Stonel™ VC&C products

PRODUCT ADVISORY BULLETIN PAB #10602 – GENERAL RELEASE

Stonel™ Axiom™ AN PFAS updates

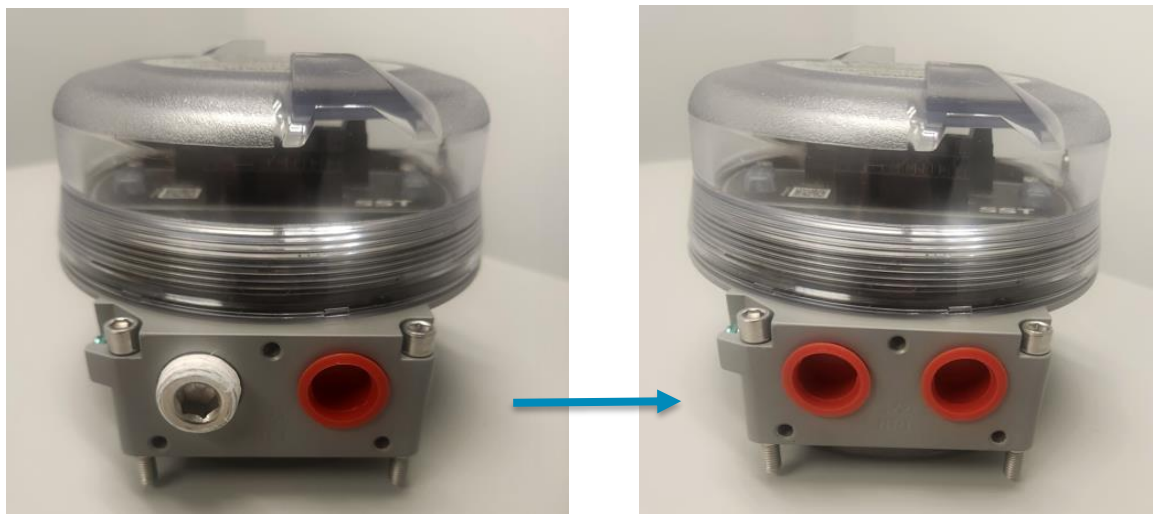
Due to upcoming legislation on PFAS restrictions, we removed the Teflon™ wrapped plug from the conduit entry for the Axiom AN with NPT housings (AN enclosures “C”, “D”, “V” and “A”). Both conduit entries now have dust cap covers as below that began shipping after mid-November 2025. Stonel explored alternative solutions for the entries, but these were cost prohibitive and would impact price.

As outlined in the IMO, devices are shipped with the conduit covers to protect the internal components during shipping, but it is the responsibility of the installer to provide the appropriate permanent sealing for devices. Please refer to the [Axiom IMO](#) for more details.
